UNITED STATES PATENT AND TRADEMARK OFFICE

10/787,124

Office Action Summary	Application No. 10/787,124	Applicant(s) STILL, THOMAS E.	
	Examiner Sean M. Michalski	Art Unit 3725

DETAILED ACTION

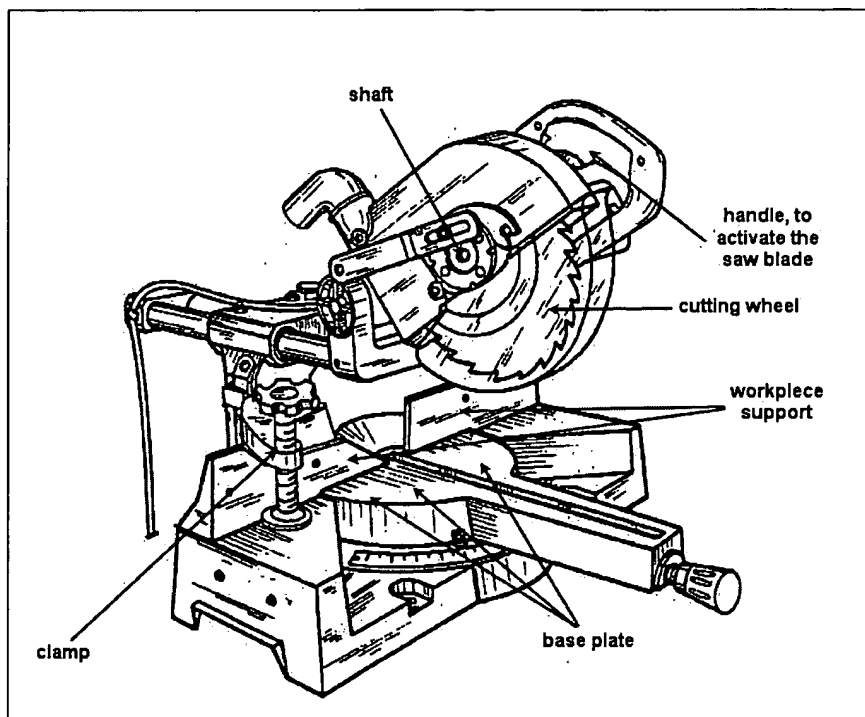
25. Claims 1 and 17 are rejected under 35 U.S.C. 102(B) as being anticipated by Arehart (USPN D336,652).

26. Regarding claim 1, Arehart discloses a cutting device, capable of cutting plastic horseshoes, comprising a base plate which bears a shaft the shaft carrying a cutting

wheel adjacent to a workpiece support. The handle activates the shaft and cutting. See commented figure below.

27. Regarding claim 17, Arehart discloses that the workpiece holder has a clamp (seen above), which is a fixing means.
